7 July 2020

**RE: Boco Rock Wind Farm Modification 1 (MP09_0103-Mod-1)
Amendment to the Modification – further reduction to Approved WTG locations**

Figure 1: Amended Project layout including Stage 1 and proposed Stage 2

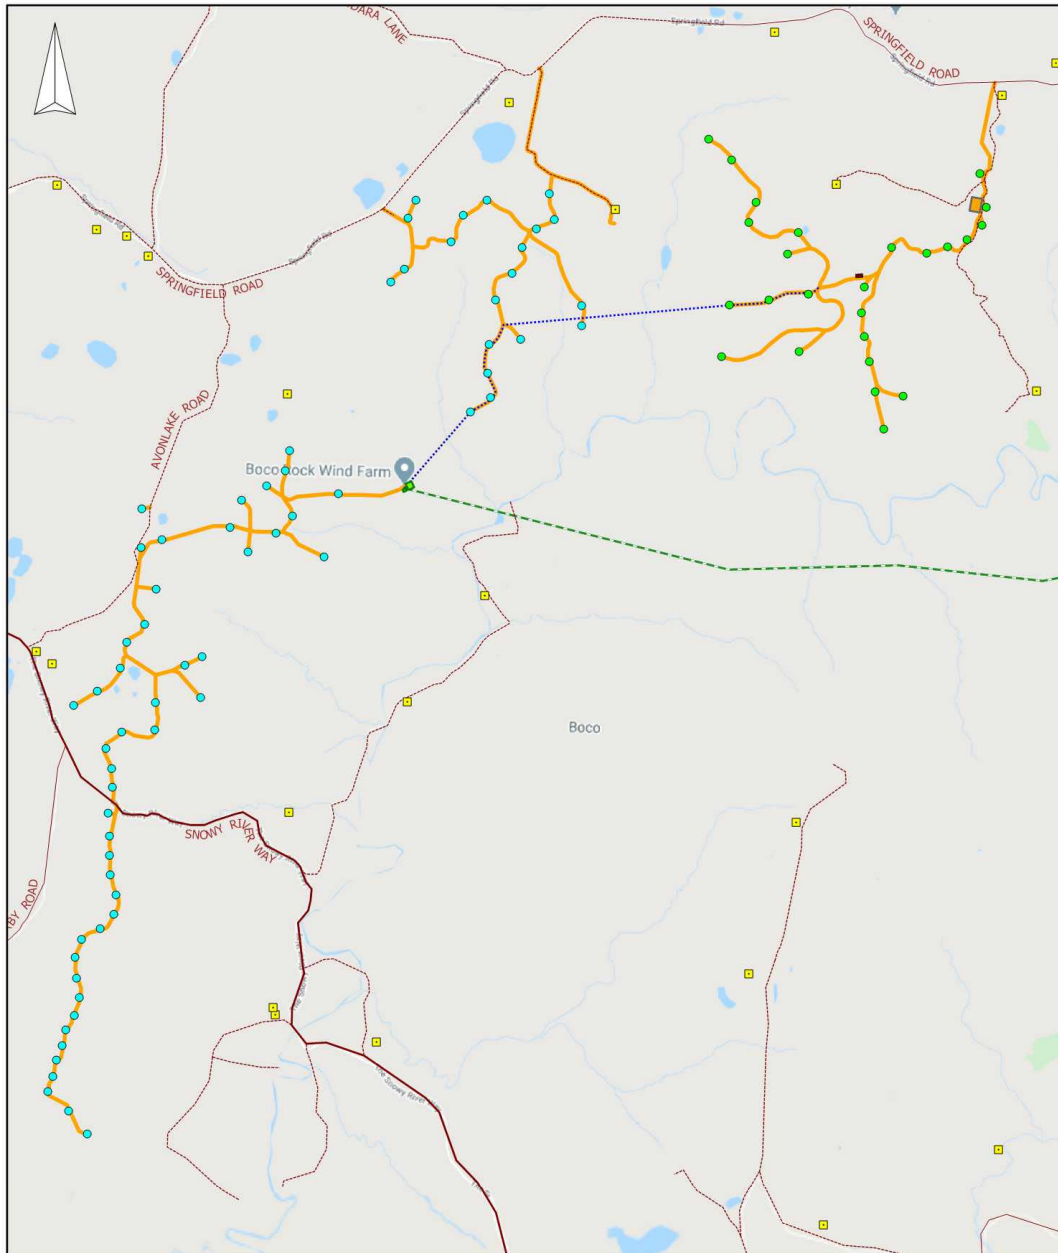
This letter seeks to amend the project to remove a further 23 approved WTG locations, (i.e. all approved WTGs from the Boco Cluster). As a result, the impacts from the 23WTGs as well as over 25 km of access tracks and electrical cabling will be removed from Stage 2. Details of the project description as updated since the Amendment Report and an impact assessment considering the removal of the Boco Cluster are provided below.

Overall, the Modification is forfeiting 35 from 55 approved WTGs and associated infrastructure yet to be constructed within the Yandra and Boco Clusters (see and Figure 2). The Modification seeks flexibility to select up to 20 WTG locations to be constructed from the remaining 25 locations identified in Figure 1 following approval. The selected WTGs would be constructed within the micro-siting allowance of 100m from the approved WTG coordinates in Annexure A.
